工程指示 / 要求簡箋 (E.I.)

工程指示編號：EI / 1472 / 20

工程名稱：青衣明翹匯住宅

工程項目：大貨試模窗

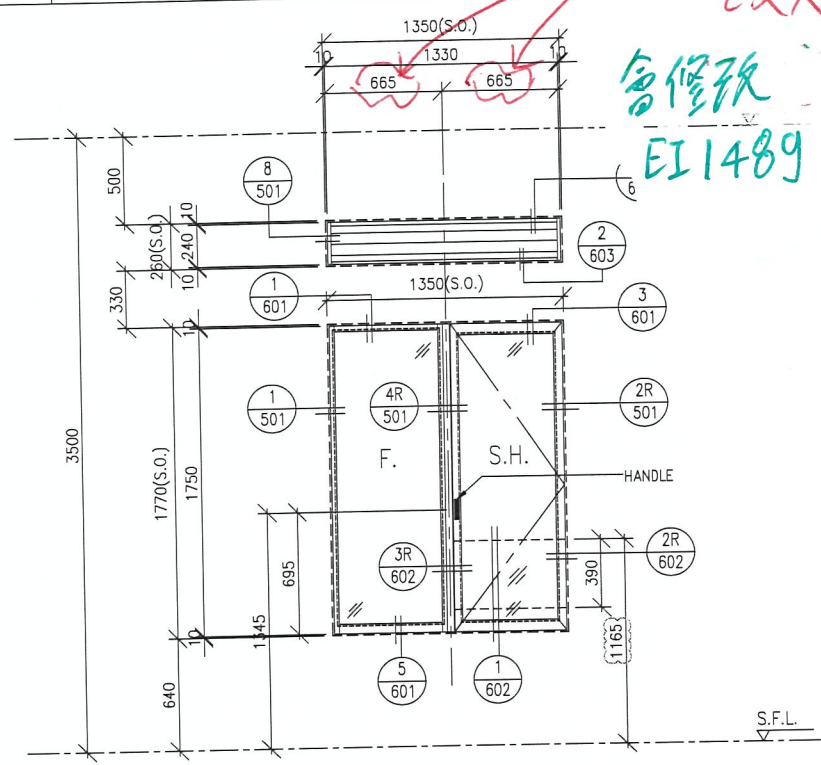
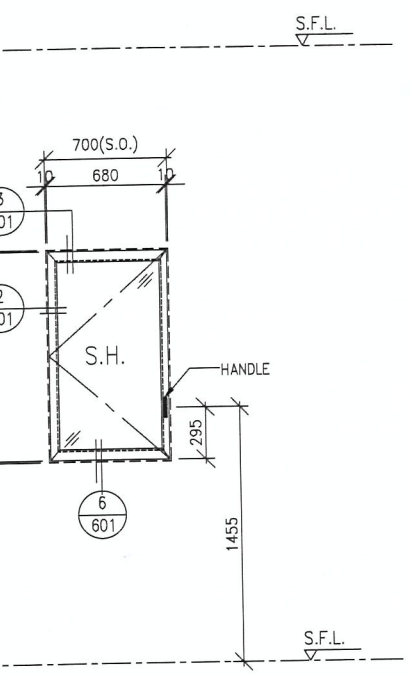
改尺寸

會修改
EI1489
